Date: August 21, 2023
Our Ref: 141040
Subject: Zoning By-Law Amendment ZBA 02-23
1060 Queen's Bush Road, Wellesley

On behalf of our client, please accept the following as our detailed response to the post-circulation comments detailed in your letter dated May 4, 2023, and the comments received through the Public Meeting held on Tuesday, May 16, 2023.

SITE PLAN

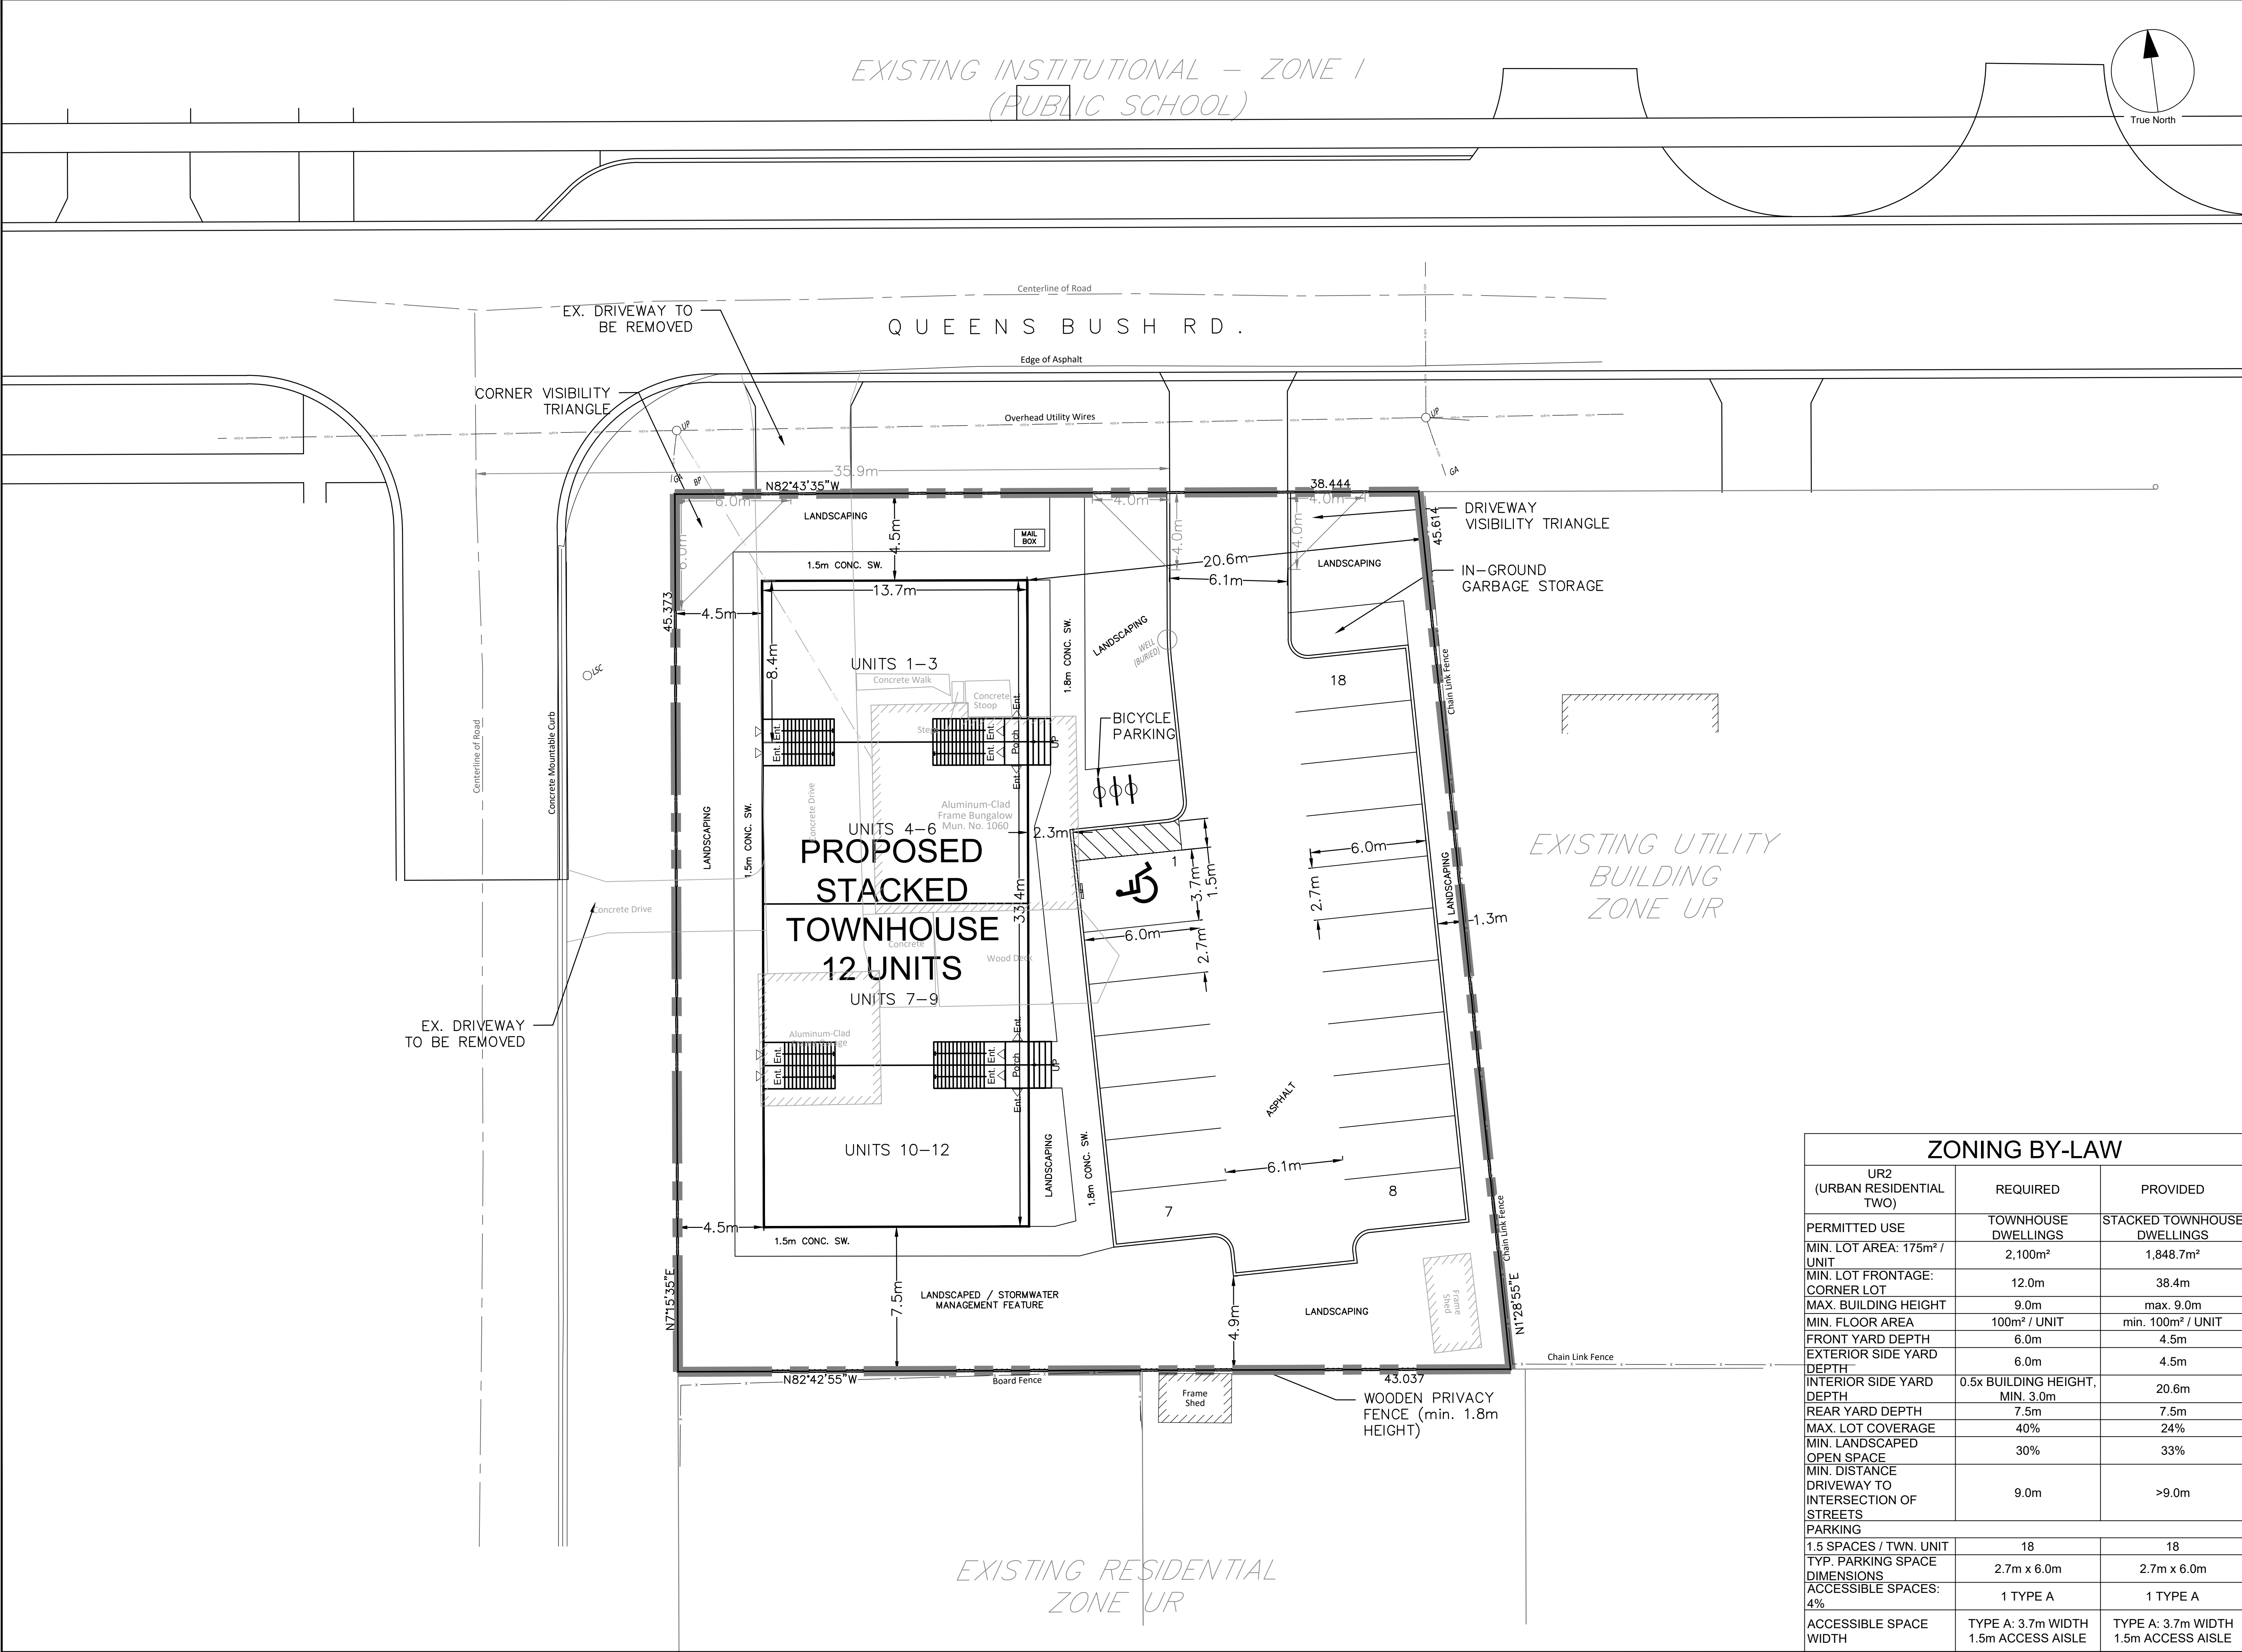
<p>Township - Landscaped Open Space – While the proposed development meets minimum landscape open space requirements (30%), no private outdoor space associated with the units has been provided. As a general design consideration, including such spaces would make for a better quality of life for residents. Please explain how this can be included in the proposed development.</p>	<p>We agree that the proposed development meets the zoning requirement for Landscaped Open Space.</p> <p>Outdoor space is proposed within the rear yard and will serve as a dual purpose to address stormwater management. We do not believe that the dual purpose will impede the opportunity for amenity space.</p> <p>The final design of the building will be determined during Site Plan Approval and private balcony areas could be considered.</p>
<p>Public – Concern that a reduced front and exterior side yard will impact the safety of pedestrians.</p>	<p>The public sidewalks are located on the opposite side of Queens Bush Road and Village Roads. Sight visibility is not impeded by the minimal reduction in front and side yard setbacks.</p> <p>Pedestrian sidewalks are built within the proposed development for each of the units.</p>

Comment	Response
Township - Visitor Parking – No street parking is permitted on Queen’s Bush Road or Village Road at this location. Is there any opportunity to provide additional parking over and above By-Law requirements?	<p>The proposed Site Plan provides for the required number of parking spaces required by the Zoning By-Law. The parking requirements include visitor parking.</p> <p>Based upon the proposed Site Plan there is insufficient area to provide additional parking spaces. It is unreasonable to ask for further parking above and beyond the By-Law requirements.</p>
Public – Concern about the number of parking spaces provided	The proposed Site Plan provides for the required number of parking spaces required by the Zoning By-Law.
Public – Concern that the parking requirement under the By-Law does not reflect the lack of public transportation in Wellesley	<p>The parking requirements are defined within the approved Zoning By-Law to which the proposed development complies with.</p> <p>Any modification to the Zoning By-Law should be discussed with the Township.</p>

Comment	Response
Township - Snow Storage – Please explain how snow storage will be accommodated on-site as this was not indicated on the proposed site plan.	Through the Site Plan process, snow storage areas would be defined, or snow would be trucked from the site.
Canada Post has reviewed the proposal for the above noted Development and has determined that the completed project will be serviced by centralized mail delivery provided through Canada Post Community Mailboxes.	A community mailbox will be located onsite, location to be approved by Canada Post through the Site Plan approval process.
Public – Concern regarding the distance of the notice mailing	The Planning Act sets out the regulations for notices related to Zoning By-Law Amendments and the Township was responsible for the issuance of the notice.
Public – Concern about the accessibility of the units	Where feasible, the ground floor residential units would be accessible.

Recognizing the proposed development approvals is currently at the Zoning By-Law stage, and through the Site Plan Review stage is where building design, materials and colours are considered.

In the interim, other examples for consideration related to building elevations and exterior finishes are provided. A specific design would be submitted through the Site Plan Review process. If the Township has some suggestions for consideration, please provide.
